FINAL DRAINAGE REPORT

MERIDIAN ROAD & BENT GRASS MEADOWS DRIVE

DATE:
November 2019

FUTURE MERIDIAN CHANNEL – PROFILE
SCALE: 1"=50' HORIZONTAL, 1"=5' VERTICAL

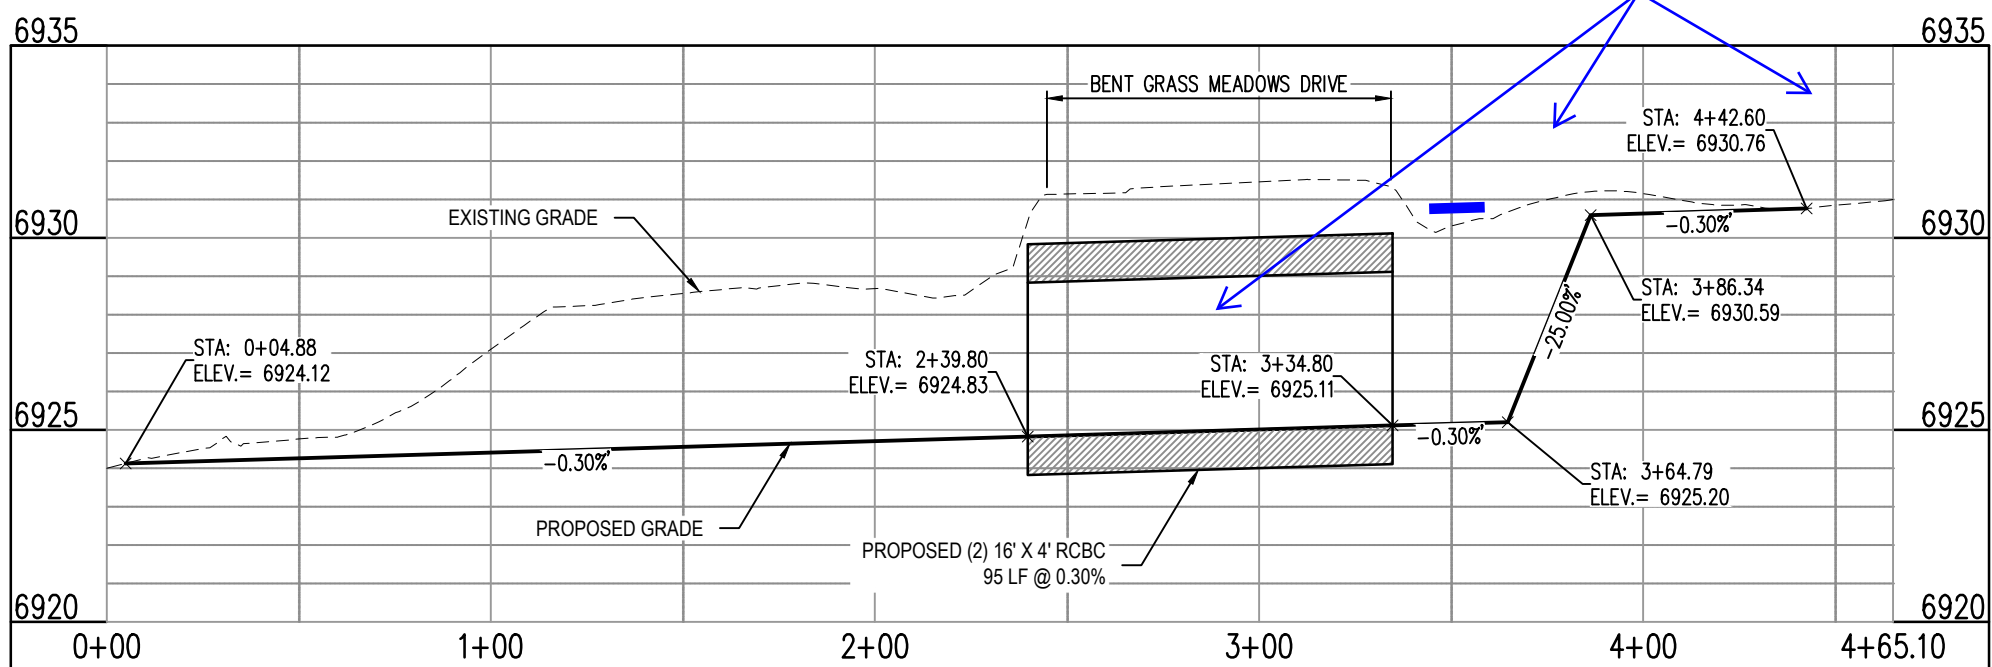
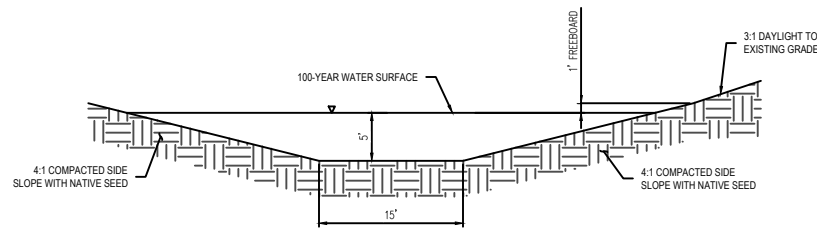
HGL line added
to profile view.
show HGL/headwater elev.
